**Datasheet for the decision
of 6 May 2025**

Case Number: T 0014/23 - 3.2.05

Title of invention:
Impregnation section of die and method for impregnating fiber rovings

D E C I S I O N
of Technical Board of Appeal 3.2.05
of 6 May 2025

Figure 1 of document D2

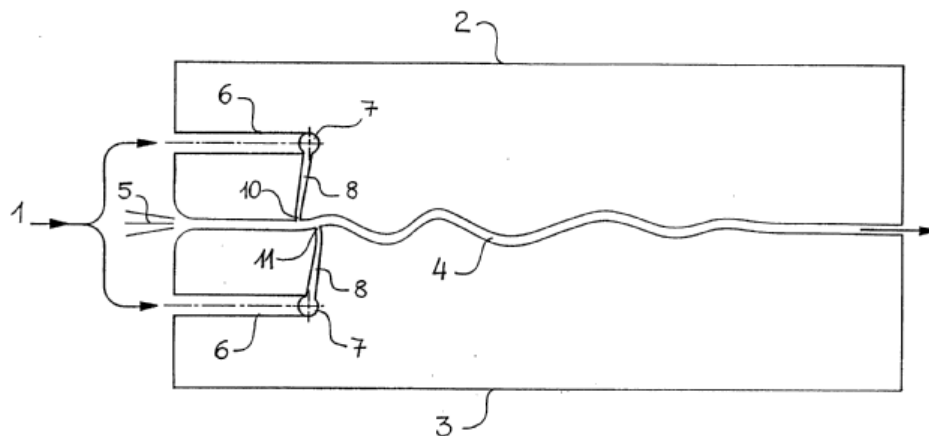
6. The appellant essentially argues that the pathway of the fibre rovings passing through the die of document D2 has an oscillation of decreasing amplitude and non-

constant wavelength, which does not conform to a sine wave and is not therefore sinusoidal.

7. In the board's view, the term "sinusoid" has a well-established meaning in mathematics: it is a curve with the general form $f(x) = A \cdot \sin(\omega \cdot x + \phi)$, i.e. which is similar to the sine function, but is possibly shifted in phase, period, amplitude, or any combination thereof. As a consequence, the appellant is correct when arguing that a damped sine wave is not a sinusoidal function.

Figure 15 of the application

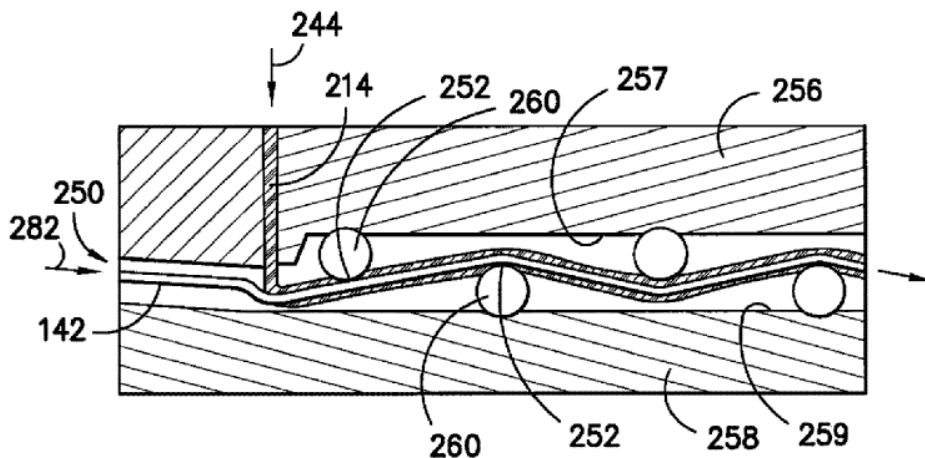
11. In the absence of any answer to the above question, it must be concluded that the appellant's argument that the deviations from a pure sine-wave form are to be restricted to the region of contact with the curved lobes is speculative and therefore without merit. The embodiments of Figures 15 to 17 of the application as

filed, which - according to the appellant - show essentially sinusoidal pathways, illustrate fibre rovings 142 following a pathway with straight sections between the contact surfaces of cylindrical pins 260. This goes against the premise that only slight deviations at the contact surfaces are permitted by the claim wording. Even if, as the appellant argues, a sinusoidal-type pathway is to be understood as an essentially sinusoidal pathway, the limitations resulting from the use of "essentially" are unclear.
